Staff Report BZA23-003-VA

Lennar Side Setbacks | Distance Between Dwellings

Meeting Date: August 3, 2023

Docket BZA23-003-VA Lennar Side Setback and Distance Between Dwelling Units Variances. The applicant is requesting two Variances (1) to reduce the side setbacks on an existing structure to reduce the side setbacks to 4.4' and 4.5' where the minimum required is 5', and (2) reduce the distance between dwelling units to 9.4' where the minimum required is 10'. The sites in question are located at 5169 and 5179 Bayberry Court in the Cardinal Pointe neighborhood in Whitestown. The applicant and owner is Lennar Homes of Indiana, Inc.

Below is the plot plan of 5169 Bayberry Court. 5179 Bayberry Court is located adjacent to the left of the site when looking at the plot plan.

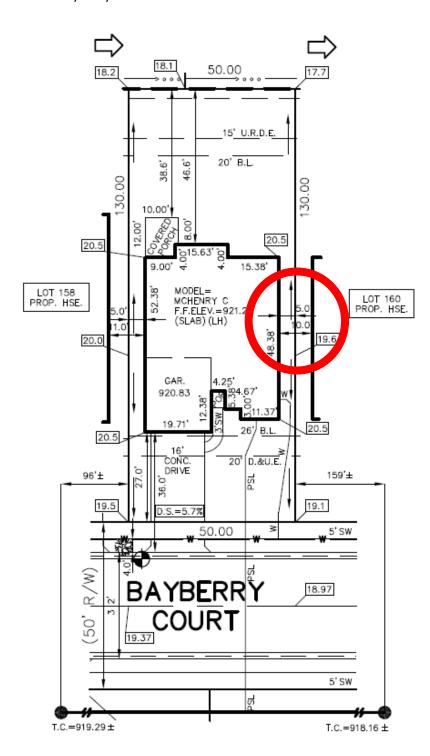
The applicant is requesting a Variance to reduce the minimum side setback from 5' to 4.4' and 4.5' for the property at 5169 Bayberry Court. The house is currently under construction. Due to the reduction in side yard setback, a reduction in distance between dwelling units is then required. The applicant is proposing to reduce the minimum distance between dwelling units at 5169 and 5179 Bayberry Court from 10' to 9.4'. The house on the other side of 5169 Bayberry Court meets the minimum required distance between dwelling units.

Staff is providing an unfavorable recommendation for the Lennar Homes 1. Reduction in the minimum setback side yard and 2. Reduction in the minimum distance between dwelling units Variances docket BZA23-003-VA.

Approval of the variance will be injurious to the public health, safety, morals, and the general welfare because as currently constructed, the house does not meet zoning or building code standards. The structure is required to have walls with a 1-hour fire rating if less than five feet from the property line. The structure is not constructed to meet that code provision making it an unsafe structure for the neighboring residences.

The strict application of the ordinance does not result in practical difficulties because the need for the variance is due to the applicant's own noncompliance with the PUD. The structure was constructed not meeting the standards, it was not a hardship imposed by the code to comply. Allowing the variance opens the gates for future homes to not due their due diligence during construction then making similar mistakes. There are no practical site difficulties or physical site constraints that would have otherwise required the home to be constructed non-conforming.

- 1. The structure at 5169 Bayberry Court must be brought up to meet the building code including the 1-hr fire rated wall in the areas where the structure is less than 5 feet from the property line.
- 2. The applicant must disclose the variances for the sites in question to future buyers of the houses. The applicant will record the official BZA findings of fact against the properties with the Boone County Recorder's Office.
